District Office- Tenant Improvement

981 Ridder Park Drive, San Jose, CA 95131
MDG Project # 2203

MECHANICAL UPGRADES – BID #B-03-2022-23
ELECTRICAL UPGRADES – BID #B-04-2022-23
GENERAL CONSTRUCTION – BID #B-05-2022-23

October 21, 2022

REFLECTED CEILING PLAN
SECOND FLOOR

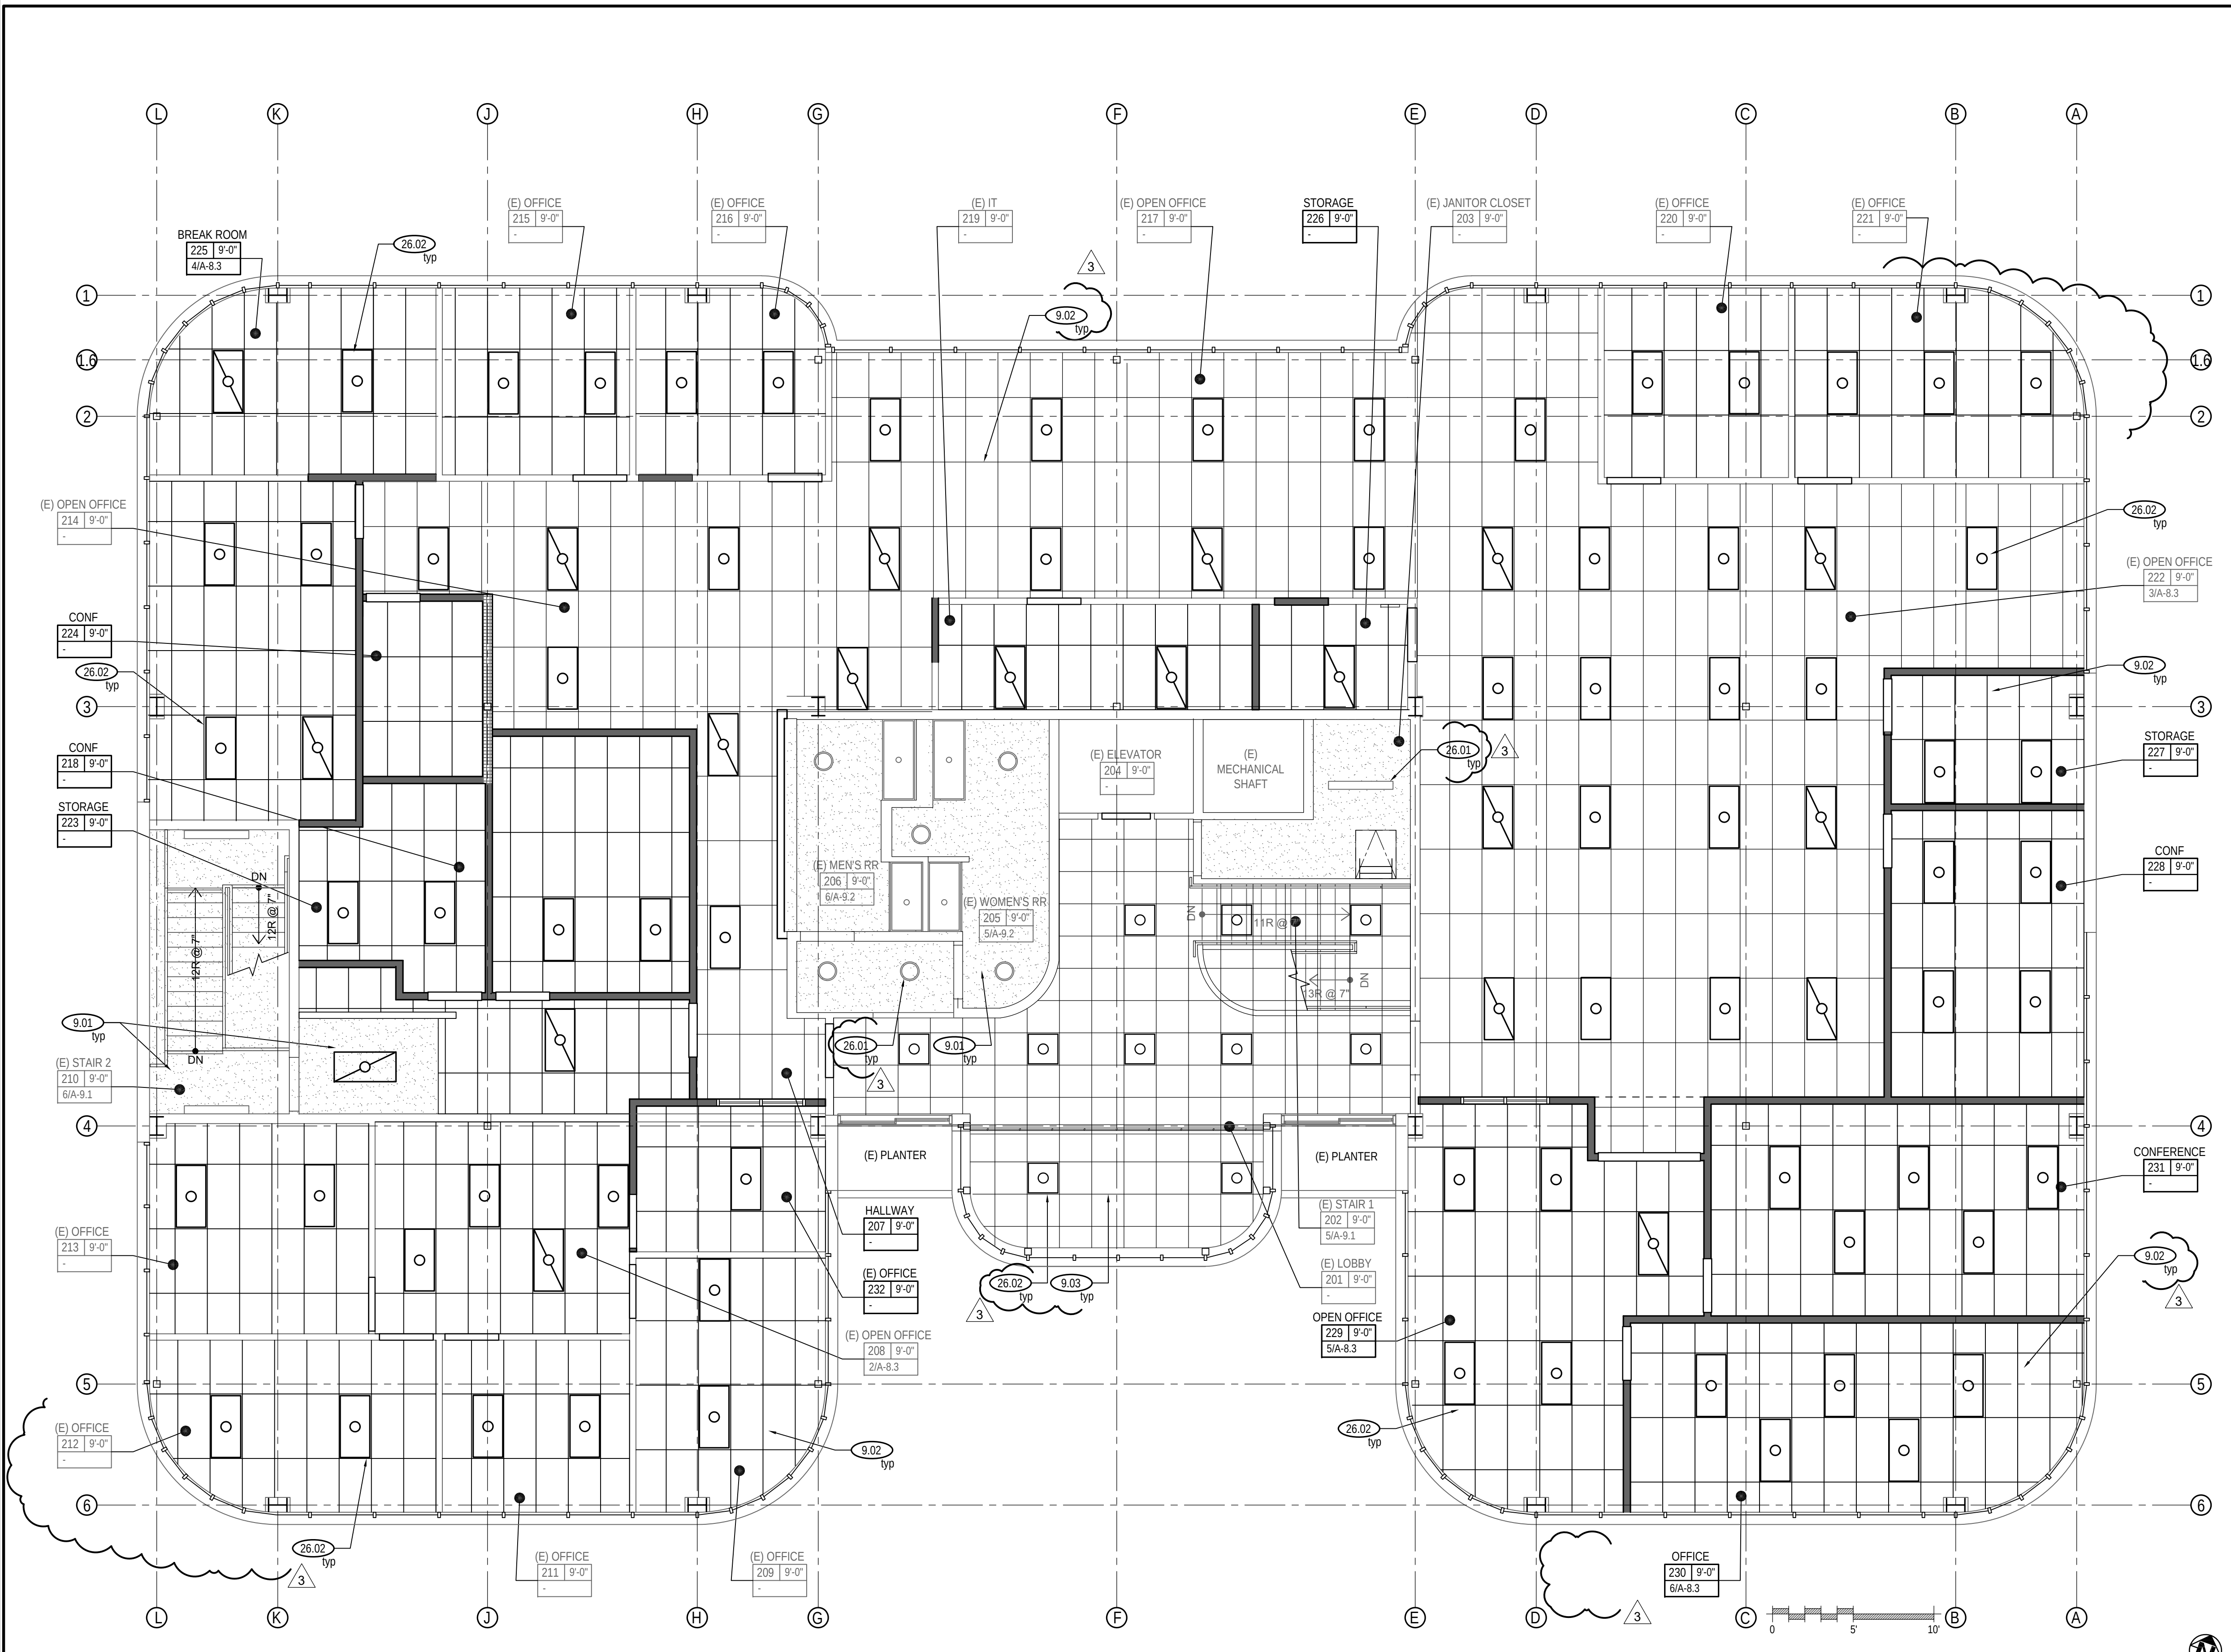
Item 9: Sheet 4.4 Reflected Ceiling Plan- Second Floor

- A. Remove Reflected Ceiling Plan-General Note #5.
- B. Revise keynote 26.01 to read existing light fixtures in gyp bd ceilings to remain.
- C. See revised keynote 26.02- light fixtures shown are diagrammatic. Final layout is to be confirmed by District and electrical plans.
- D. Remove existing light fixture symbol under Legend.
- E. Clarification- See revised keynotes, legend and reflected ceiling plan for grid size and type of tiles.
- F. Remove Storage 230.1 and provide t bar grid per plans.
